### STANDpoint Special Edition

## Effectiveness of the Perched Aquifer Pump and Treat System

December 2005

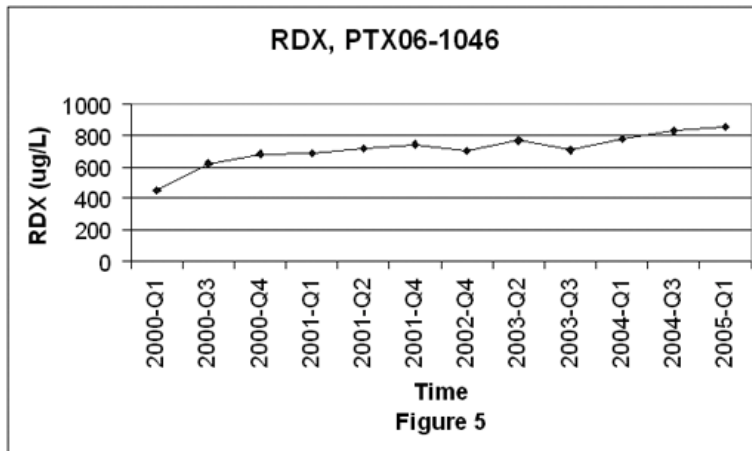
To date, cleanup appears to have been effective in only one of the selected wells: PIX06-1005 (figure 1). Between 1999 and 2005, RDX concentrations dropped from approximately 1000  $\mu\text{g}/\text{L}$  to 20  $\mu\text{g}/\text{L}$ . This is less than the TCEQ Industrial Risk Reduction Standard 2 level of 26  $\mu\text{g}/\text{L}$ <sup>3</sup>. However it is higher than the EPA lifetime health advisory of 2  $\mu\text{g}/\text{L}$ <sup>4</sup>.

Well PTX06-1005 is near a clean-up system injection well<sup>5</sup>. This may be the reason RDX concentrations have decreased as much as they have.

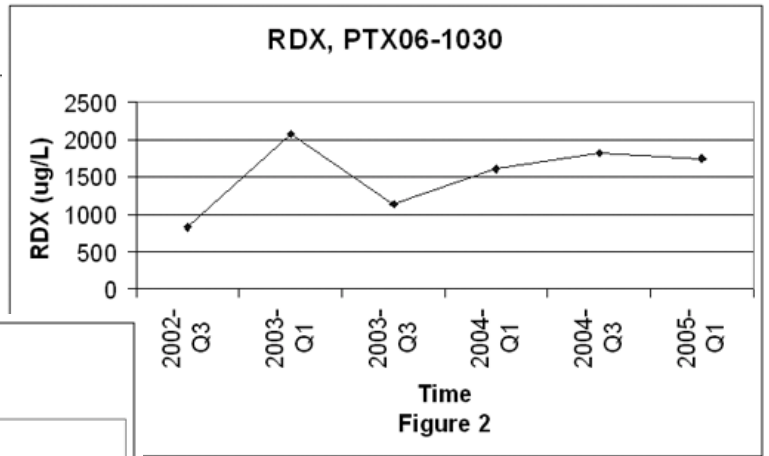
RDX concentrations have declined in some wells (e.g., PTX06-1042, figure 4) and increased in others (e.g., PTX06-1046, figure 5). Still, except for well PTX06-1005, RDX concentrations remain high in all the wells (figures 2 – 7), far above any standards established to protect human health.
